**Addendum No. 1  
to the Bidding Documents**

**Steven Mills Sewer and Sidewalk  
Replacement Project  
Town of Dudley**

**Issued April 24, 2024**

**TYPICAL WHEELCHAIR RAMP - TYPE 1**  
NO SCALE

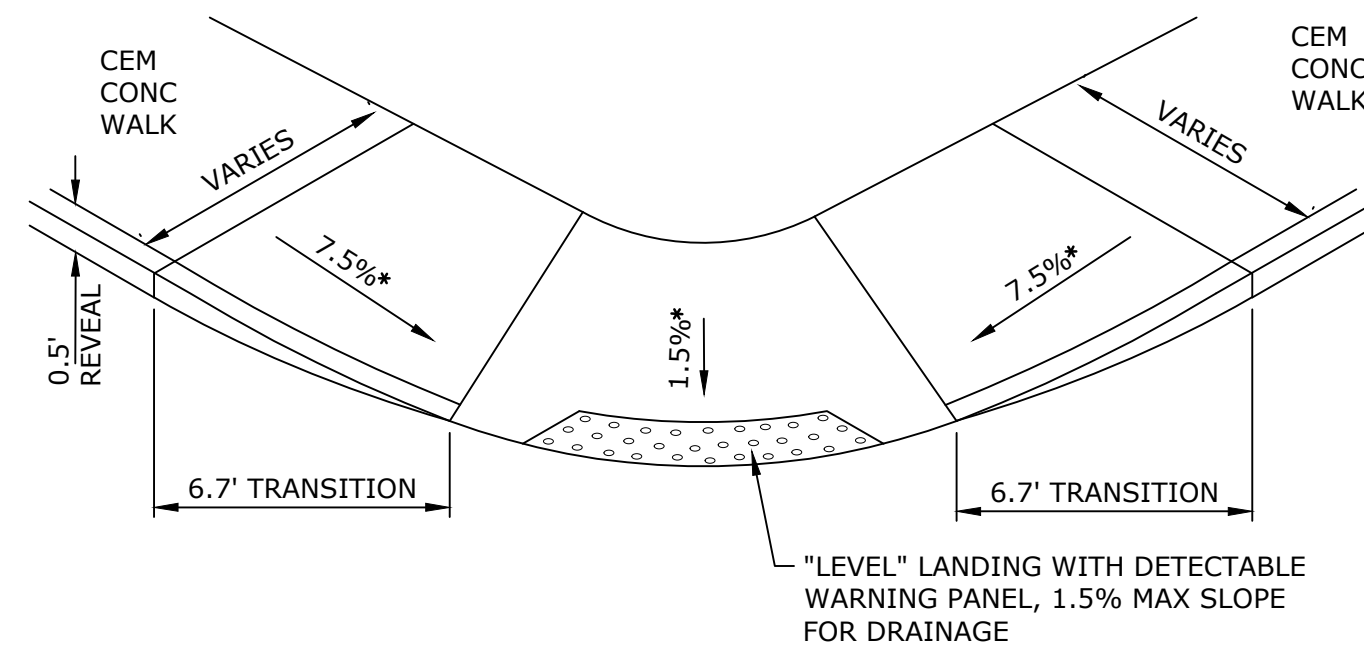
**Delete** Drawing C-501 in its entirety and **replace** it with the attached Drawing C-501. The Typical Wheelchair Ramp Detail has been updated to indicate that the granite curb will not continue flush through the front of the ramp.

**ROAD WIDENING DETAIL**  
NO SCALE

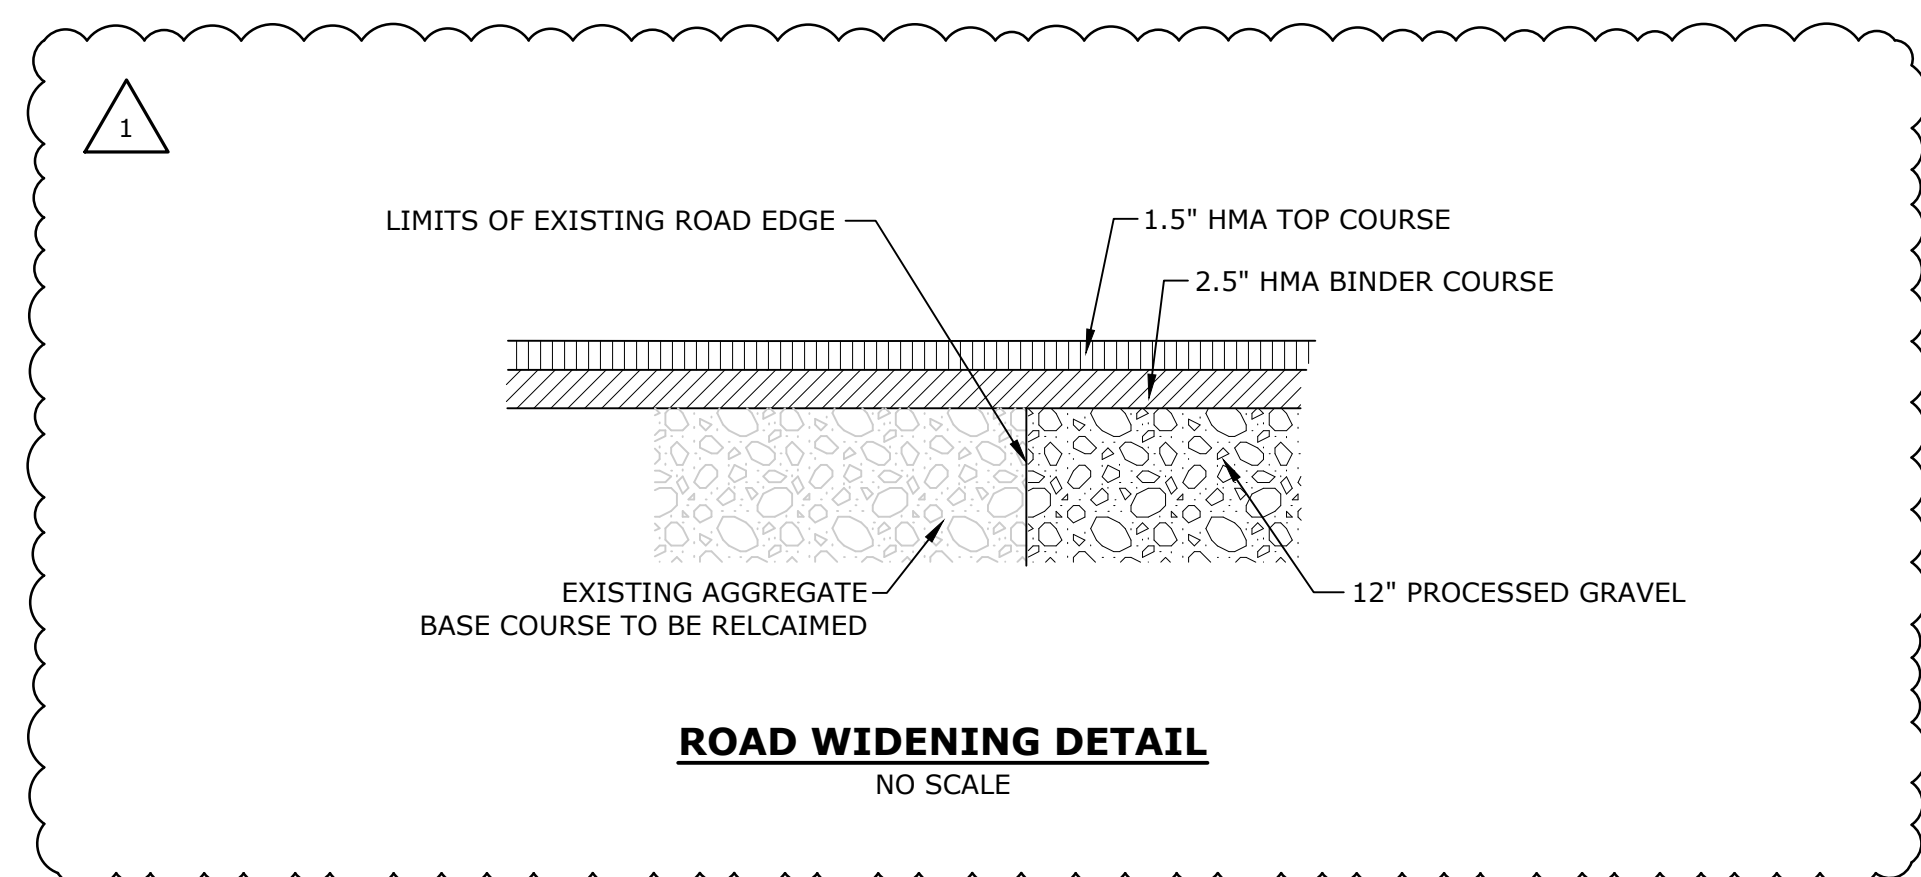
**Delete** Drawing C-502 in its entirety and **replace** it with the attached Drawing C-502. Road Widening Detail has been added.
